MI17-03

DATE: January 2017 SECTION: 06 ELECTRICAL
SUBJECT: Dash backlights always on after MUX update

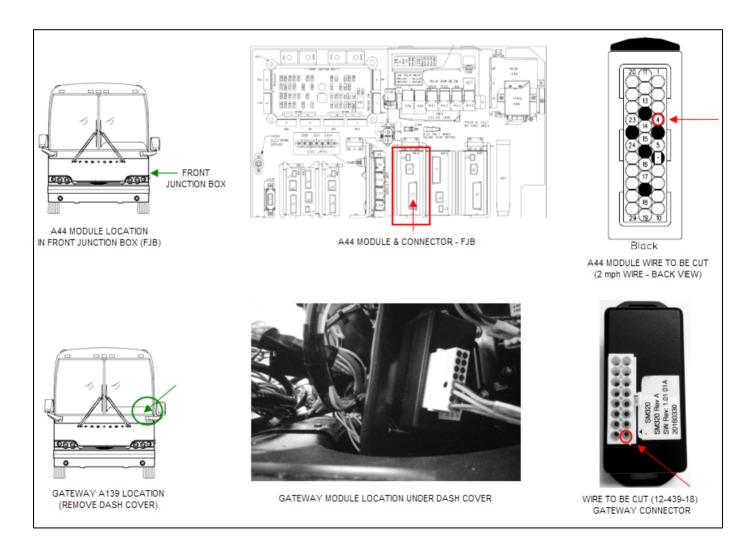
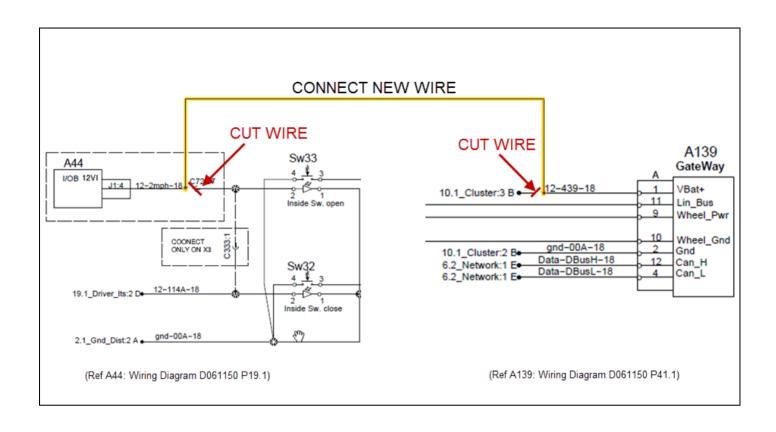
After the installation of the latest Multiplex system update on US10 X3-Series coaches, the instrument panel and switches backlighting may stay constantly on due to an output (J1:4) on the A44 module sending constant current to the 114A circuit via the 2mph wire. This wire should be connected only for Commuter application and must be removed on coaches. To retain gateway module watchdog timer (WDT) function, a new wire must be routed and connected between module A44 output and the Gateway module. Refer to page 2 & 3 for complete instructions.

- 1. Inside the vehicle, remove the dash cover and locate the Gateway module.
- 2. Cut wire 12-439-18 going to the Gateway connector (leave about 3 inches of wire at the connector).
- 3. Inside the front junction box (FJB), locate module I/OB A44 and cut 2mph wire, <u>leaving about 3 inches</u> of wire at the connector end.
- 4. Using a splice connector #562935, connect a 6 ft. yellow 18ga wire (#562993) to the 2mph wire (connector side).
- 5. Pass the wire under the dash inside the driver's compartment (reach the Gateway module).
- 6. Connect the wire to the remaining 12-439-18 wire at the Gateway connector using a #562935 splice connector.
